Subject: 05015 Safety Recall
 Seat Latch Release Lever Actuation

Models: 2005 Chevrolet Uplander
 2005 Pontiac Montana SV6
 Equipped with Second Row Bucket Seats (AL4)

SUBJECT: SEAT LATCH RELEASE LEVER ACTUATION

**MODELS: 2005 CHEVROLET UPLANDER
 2005 PONTIAC MONTANA SV6
 EQUIPPED WITH SECOND ROW BUCKET SEATS (AL4)**

1546920

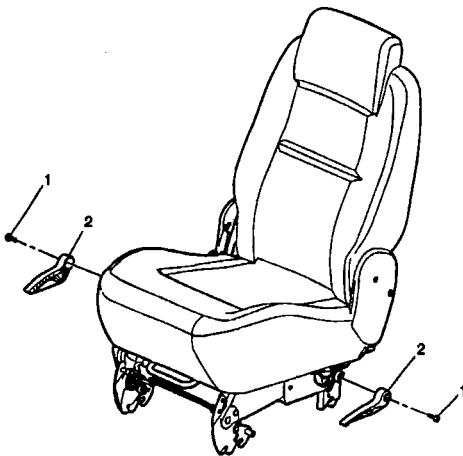
General Motors has decided that a defect, which relates to motor vehicle safety, exists in **certain** 2005 model year Chevrolet Uplander and Pontiac Montana SV6 vans. In a severe side impact test, a part of the vehicle deformed and actuated the outboard release handle of a second-row bucket seat and the rear latches became unlatched early during the crash sequence. If the rear latches of the seat are released early in a severe side impact crash, the potential for injury to the occupant of the seat is increased.

Dealers are to remove the seat latch release handle and install a black plastic cap over the exposed metal stud to eliminate the side impact safety concern. Please note that even though the handle is not being replaced, seat functionality is not diminished as the primary release strap remains at the rear of the seat

1. Remove the rear seat latch handle screw (1).
2. Remove the rear seat latch handle (2) from the rear seat.
3. Install a new cap over the end of the rod.
4. Repeat steps for the rear seat on the other side of the vehicle, if applicable.
